**Rix's Creek Mine Extension Project (SSD_6300)
Response to exhibition of Environmental Impact Statement**

Rix's Creek Extension project (SSD 13_6300) Response to exhibition of Environmental Impact Statement DPI Water – Detailed Comments

Plan

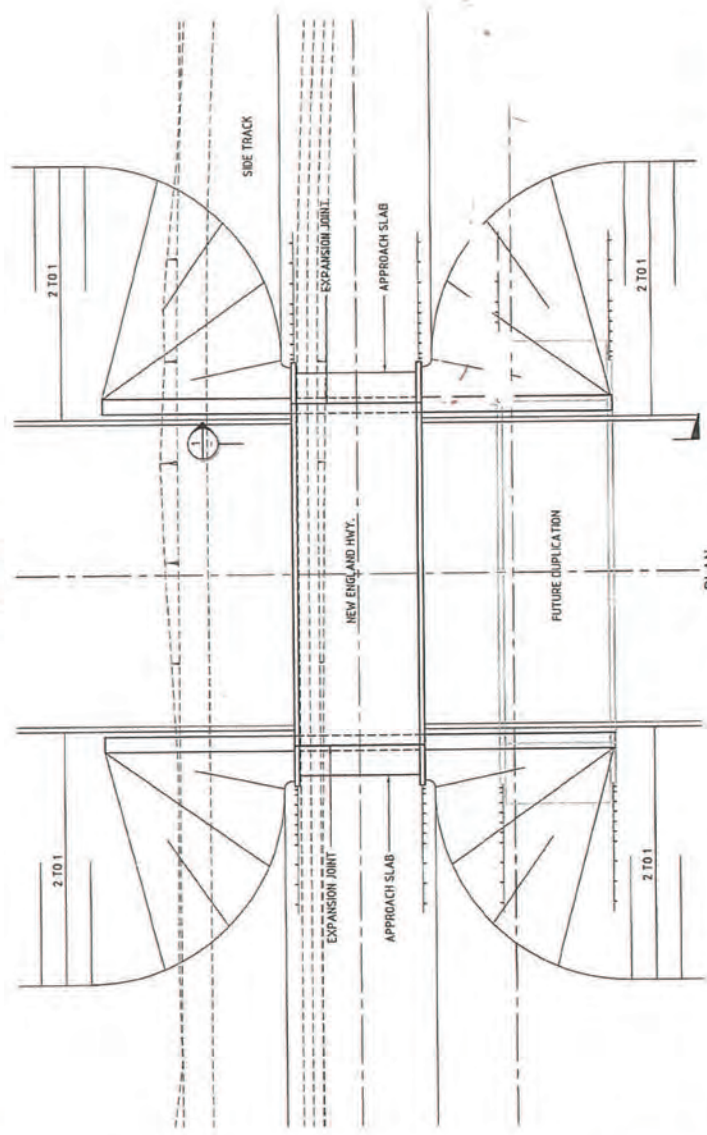
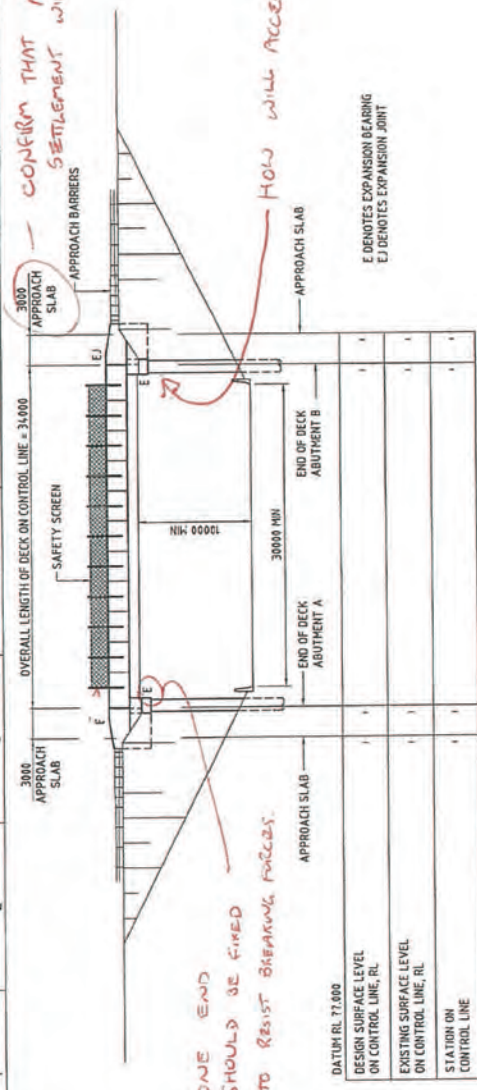
* Show location of

FIBRE OPTIC CABLE ON

SECTION 1
SCALE 1:100

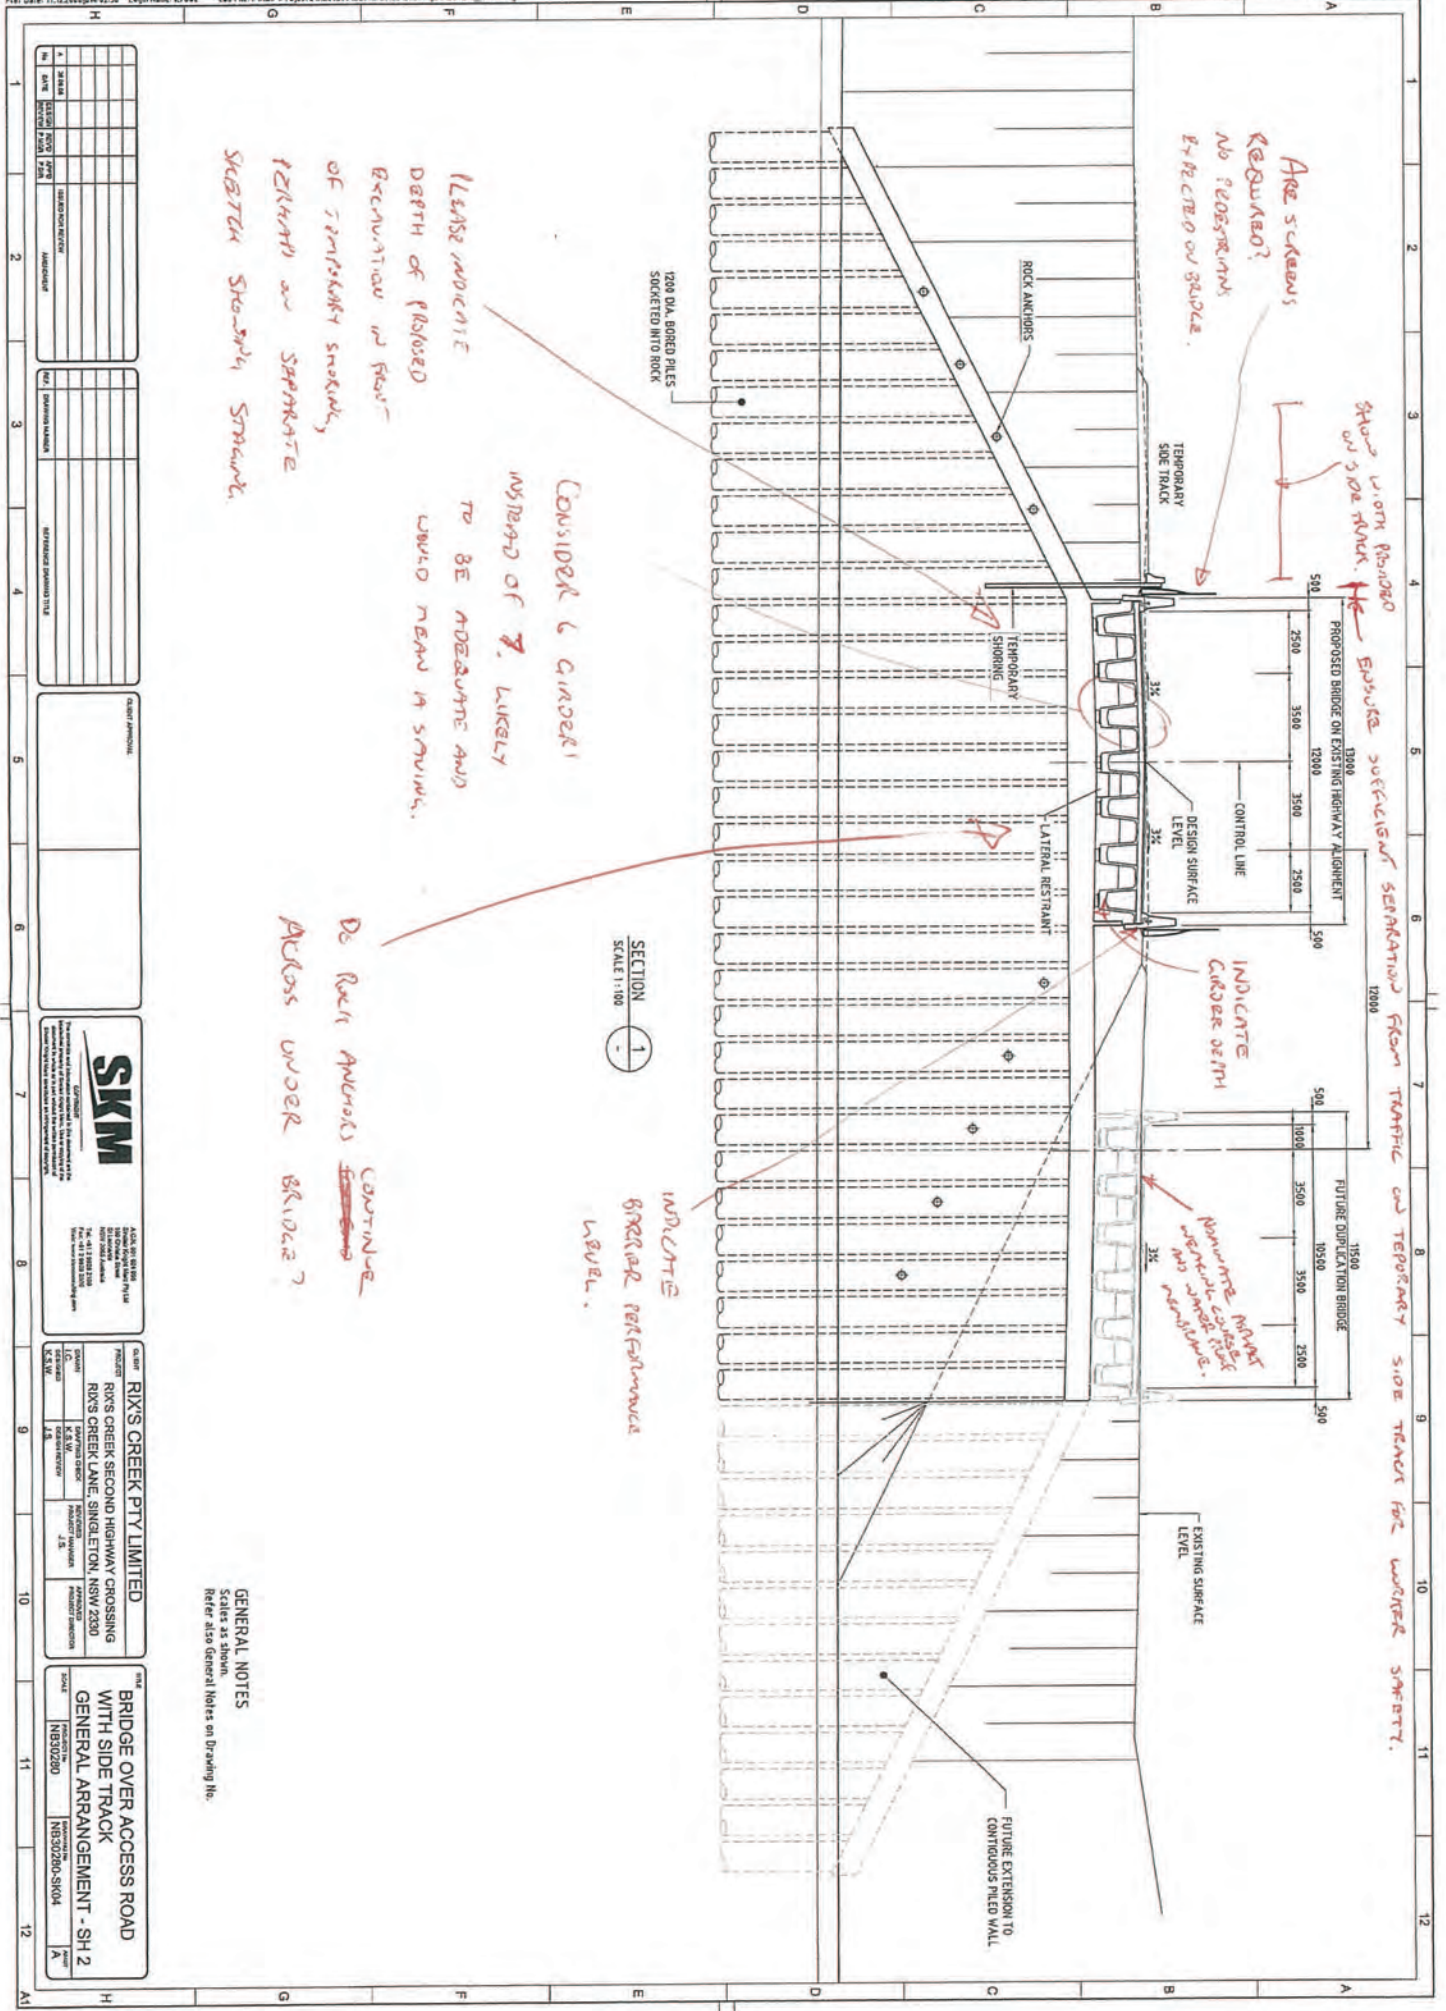
- * BRIDGE DESIGN SHOULD CONFORM TO RMS BRIDGE TECHNICAL DIRECTIONS AND STANDARD DRAWINGS.
